STATE OF NORTH CAROLINA
DEPARTMENT OF TRANSPORTATION

Subject: **Revised Modification Request for Section 404 Individual Permit and Section 401 Water Quality Certification** for the widening of NC 49 from East of NC 73 to East of SR 2630 (Cline Road) in Cabarrus County. Federal Aid Project No. NHS-0049(26), Division 10, TIP No. R-2533CC.

Reference: USACE Individual Permit Action ID SAW-2010-00726, dated June 6, 2011.
NCDWQ Water Quality Certification No. 003847, dated January 19, 2011.
R-2533CC Permit Modification Application dated January 20, 2012

Site 7

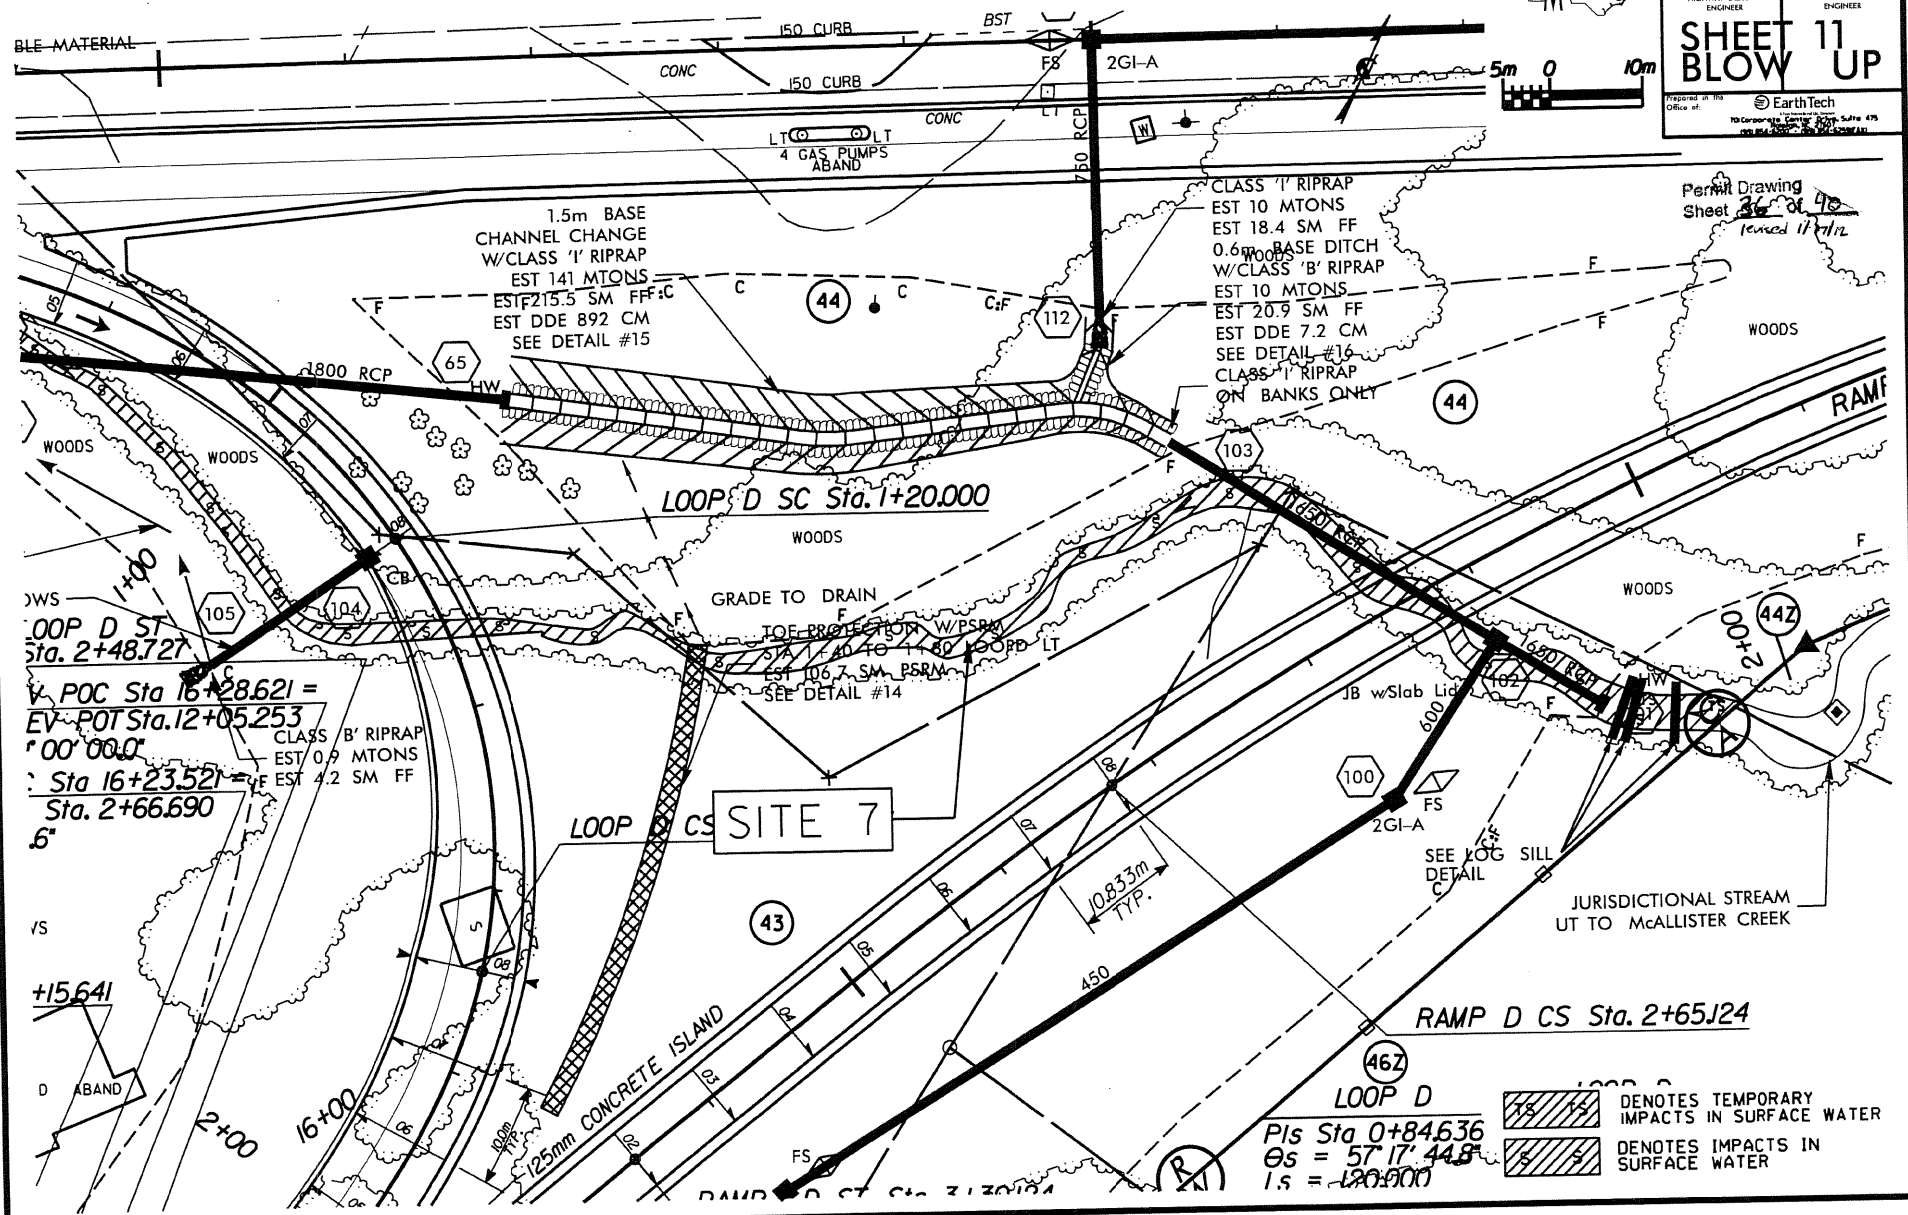
Currently there is a considerable elevation difference between the undisturbed portion of the stream and the pipe inlet. There is approximately 2.85 feet of fall occurring within the approximate 26 feet of stream as it enters the pipe. NCDOT proposed to rectify this problem by installing a log sill in the area of the stream before it enters the pipe. The log sill will be used to direct the stream flow (thalweg)

toward the center of the channel and to provide grade control. The log will be constructed of hardwood tree species with a minimum diameter of 12-inches. The length of each log shall be sufficient to allow proper construction and so they can be keyed into the banks at a minimum of 1.5 meters (Approximately 5 feet).

The permanent impacts at Site 7 will change from 902 linear feet to 928 linear feet. The temporary impacts will decrease from 43 feet to 17 feet.

New Revised 3/5/12

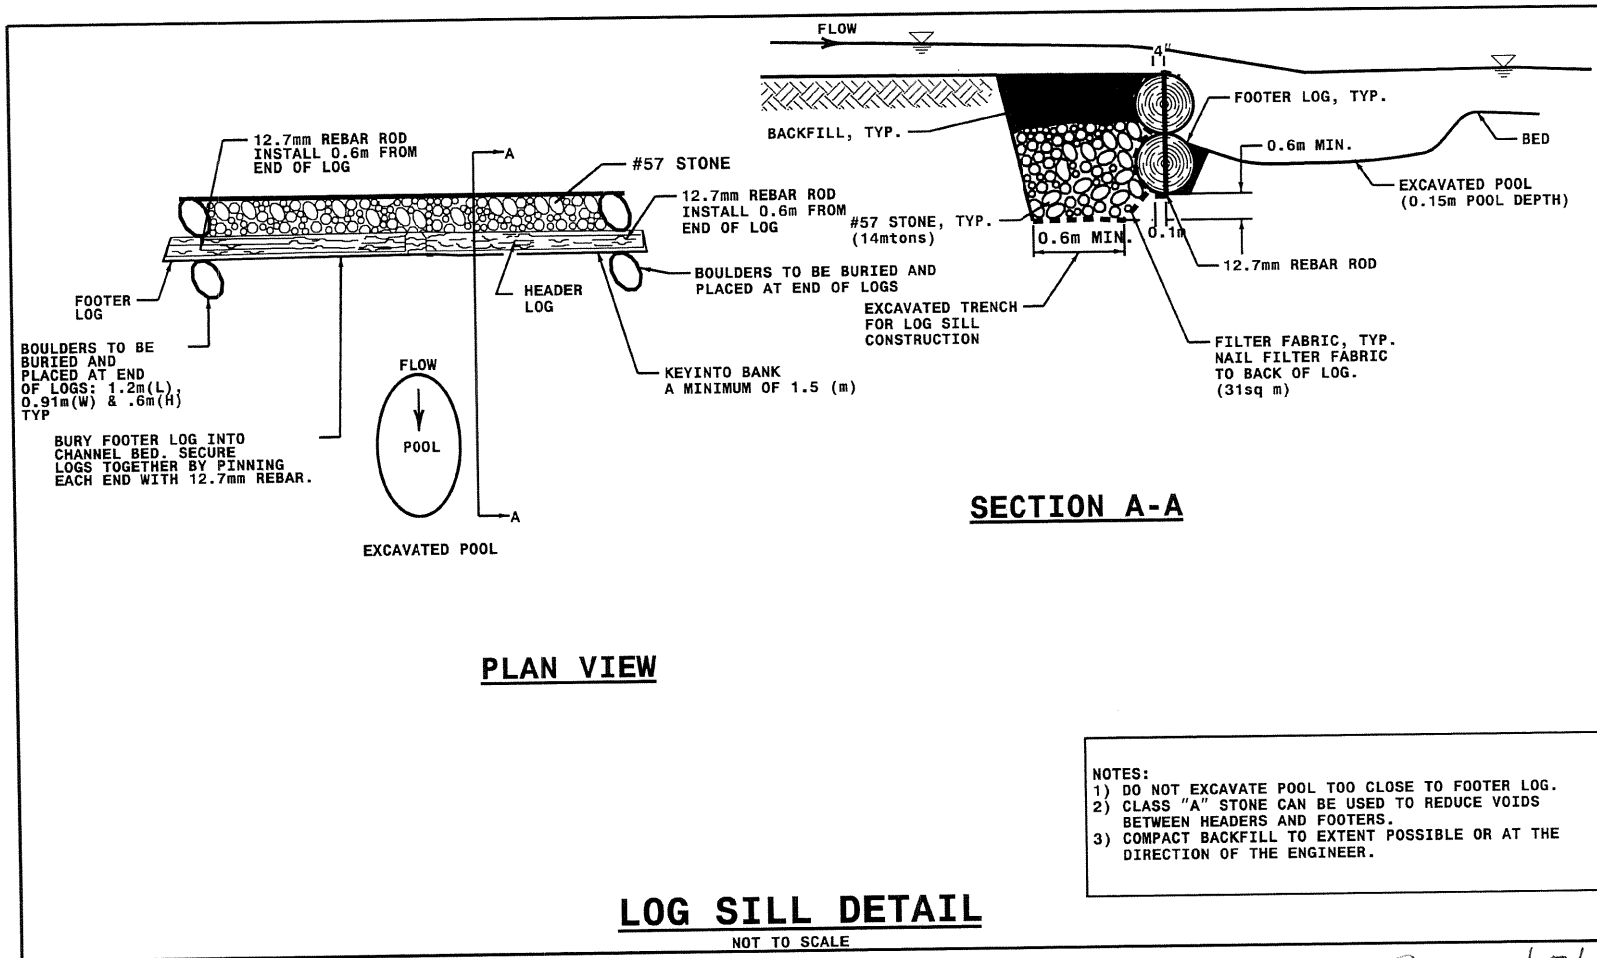
- NOTES:
- 1) DO NOT EXCAVATE POOL TOO CLOSE TO FOOTER LOG.
 - 2) CLASS "A" STONE CAN BE USED TO REDUCE VOIDS BETWEEN HEADERS AND FOOTERS.
 - 3) COMPACT BACKFILL TO EXTENT POSSIBLE OR AT THE DIRECTION OF THE ENGINEER.

New Permit site 1A

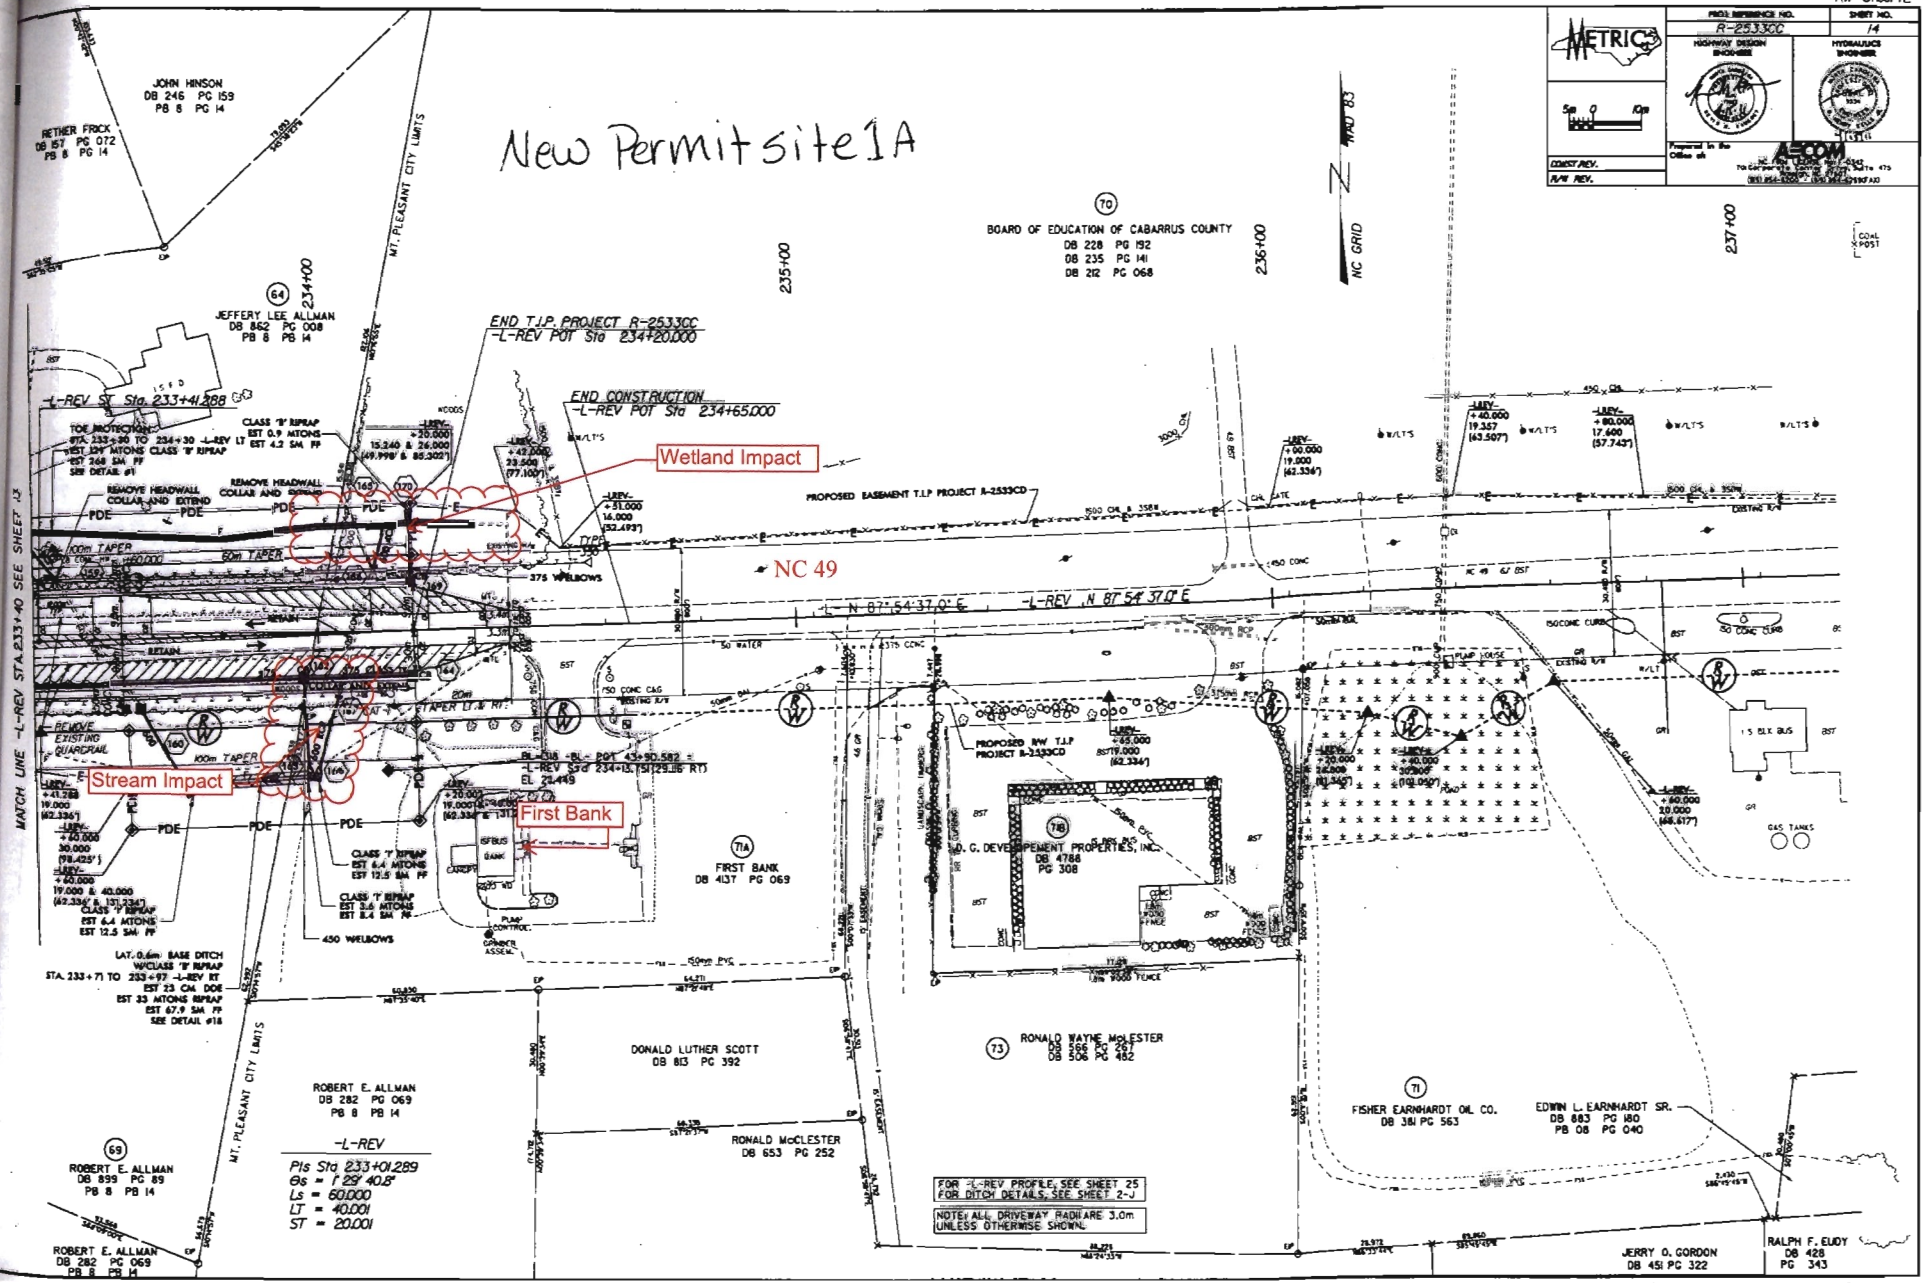
This is a newly found site with a wetland and stream located on NC 49 adjacent to the First Bank and east of Skyland Drive. There are 85 linear feet of permanent stream impacts consisting of 60 feet of fill due to the extension of a pipe and 25 feet of fill due to rip rap placement. Also at this site, 0.103 acre of wetland has been cleared and partly filled on the north side of NC 49.
